Joint Meeting of Experts on the Regulations annexed to the European Agreement concerning the International Carriage of Dangerous Goods by Inland Waterways (ADN) (ADN Safety Committee)

Report of the tenth Meeting of the Informal Working Group on Explosion Protection on Tank Vessels

Proposals to implement the new zone concept in ADN

No service spaces within cofferdam

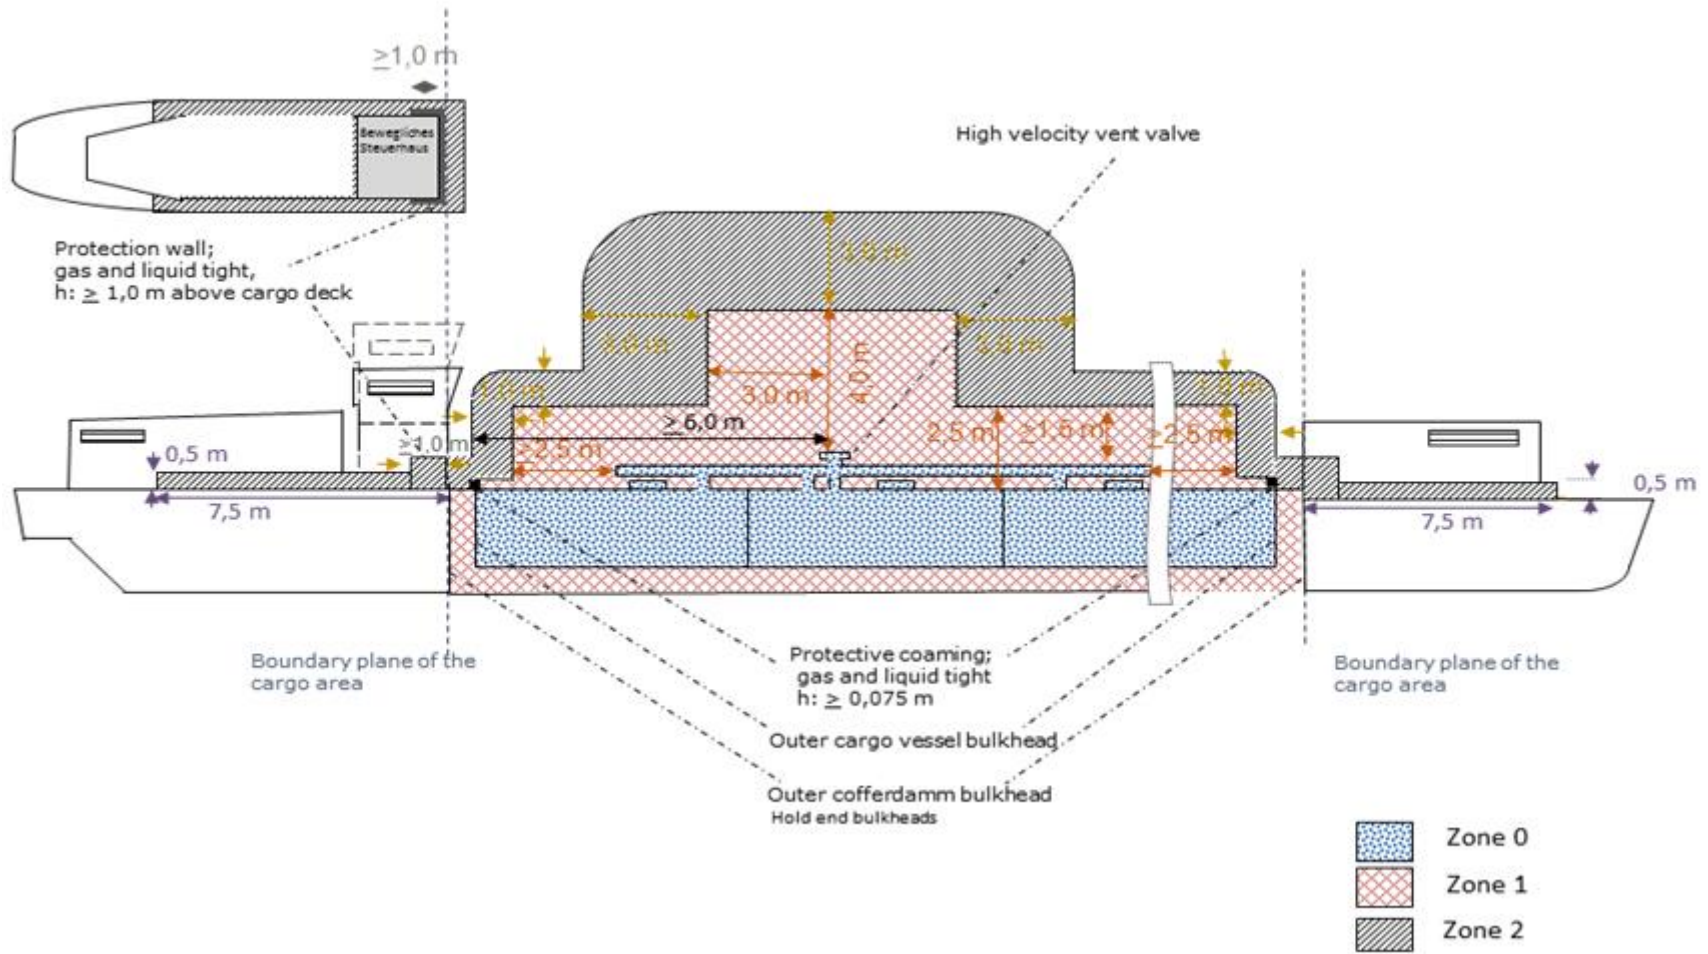
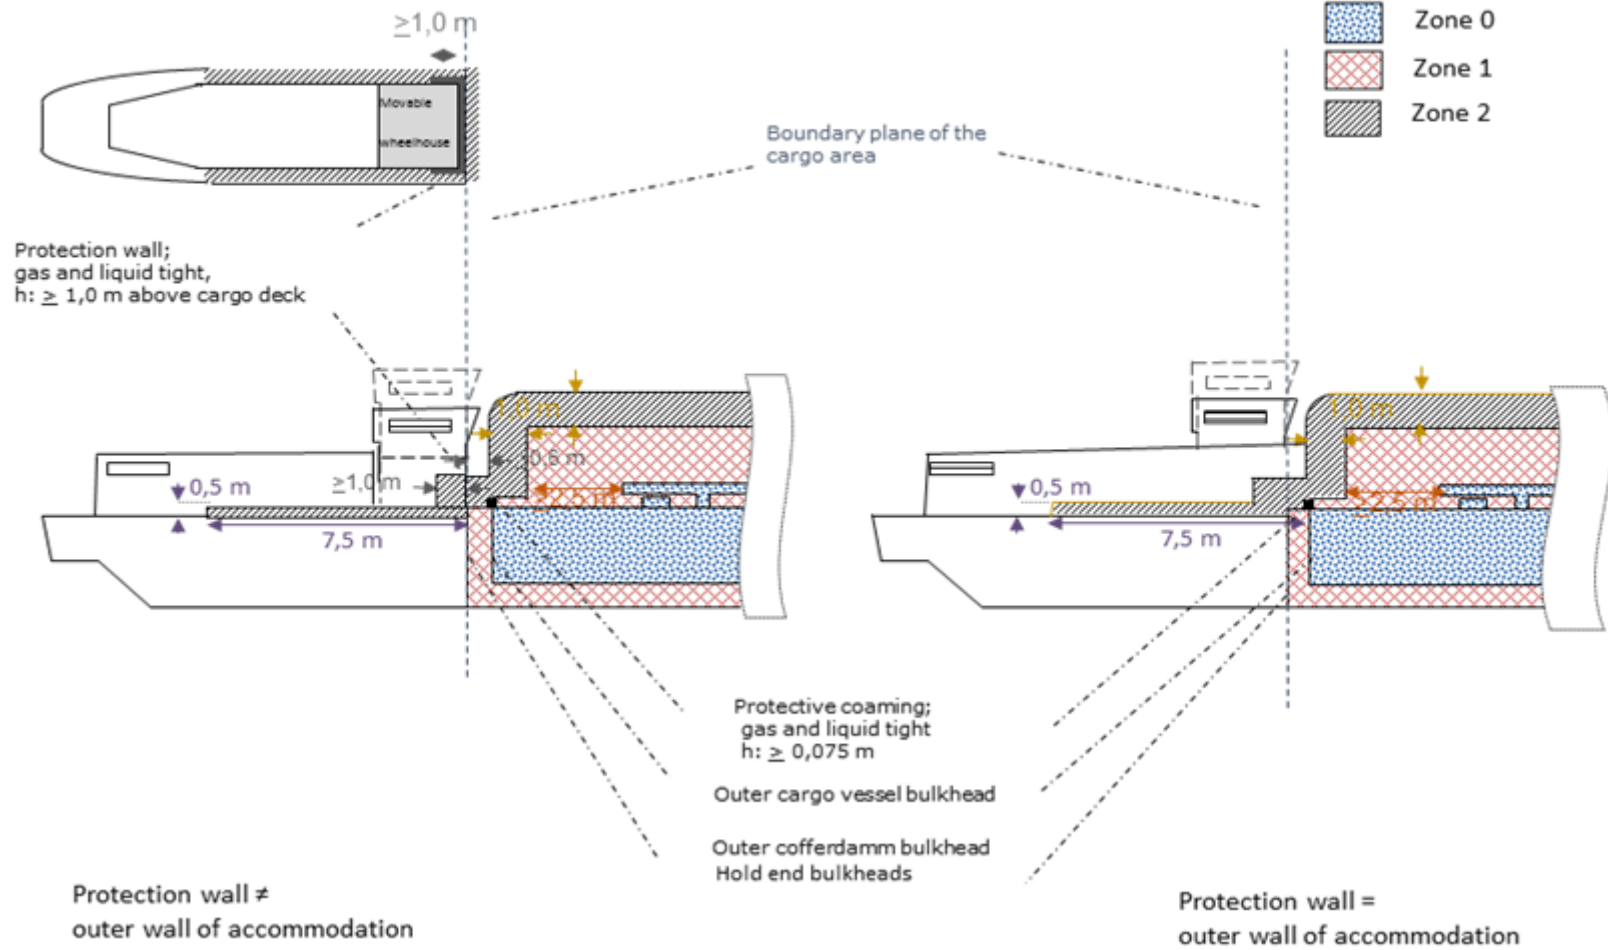
<p><i>Zoning</i> <i>Classification des zones</i> <i>Zoneneinteilung</i> <i>Классификация зон</i></p>	<p>Zoning This zoning applies for tank vessels whose list of substances on the vessel according to 1.16.1.2.5 contains substances for which explosion protection is required in column (17) of Table C of 3.2.3.2 (see drawing)</p> <p>Zone 0: comprises:</p> <ul style="list-style-type: none"> -  <u>de all cargo tanks, tank-containers or portable tanks, pipings containing cargoes or cargo vapours including their equipment as well as pumps and compressors.</u> <p>Zone 1: comprises:</p> <ul style="list-style-type: none"> -  <u>compartments within the part of the cargo area below deck being not part of zone 0.</u> - <u>Compartments on deck within the cargo area.</u> - <u>The deck from one side of the vessel to the other within the cargo area up to the cofferdam bulkheads.</u> <p><u>Up to a distance of at least 1.6 m to the boundary plane of the cargo area the height is 2.5 m above deck, at least, however, 1.5 m above the highest piping carrying cargoes or cargo vapours. Adjacent (fore and aft) till the outermost cargo tank shots the height is 0,25 m above deck. If there is a pump room installed inside the cofferdam the adjacent height (fore and aft) is 1.0 m above deck (see drawing).</u></p> <p><u>Adjacent (fore and aft) till the outer cargo tank bulkhead the height is 0.25 m.</u></p> <p><u>In case there are service spaces within the cofferdam or the vessel is build having hold end bulkheads the adjacent height (fore and aft) till the boundary plane of the cargo area is 1.0 m</u></p> <p><u>Whereas every opening in zone 0 except the high velocity vent valve has to be surrounded cylindrically by at least 2.5 m zone 1</u></p>	New zone concept

en, fr, de, ru	Paragraphs	Reason / Explanation
	<ul style="list-style-type: none"> - <u>An area surrounding cylindrically the high velocity vent valve/safety valve of cargo tanks of type G vessels with a radius of 3.0 m up to a height of 4.0 m above the opening of the high velocity vent valve/safety valve of cargo tanks of type G.</u> 	
	<ul style="list-style-type: none"> - <u>A spherical segment surrounding the ventilation openings of the service spaces located within the cargo area which are actively ventilated, comprising a radius of 1.0 m centred over the opening.</u> 	
	Zone 2: comprises:	
	 <u>An area on deck of 1.0 m in height and length following zone 1.</u>	
	<u>On the fore deck and the aft deck an area of the entire width of the vessel adjacent to boundary plane of the cargo area, with a complete length of 7.5 m. Between the lateral side of the vessel and the protection wall this area equals the length and height of the dimensions of the lateral side of the protection wall. Apart from that, the height is 0.5 m.</u>
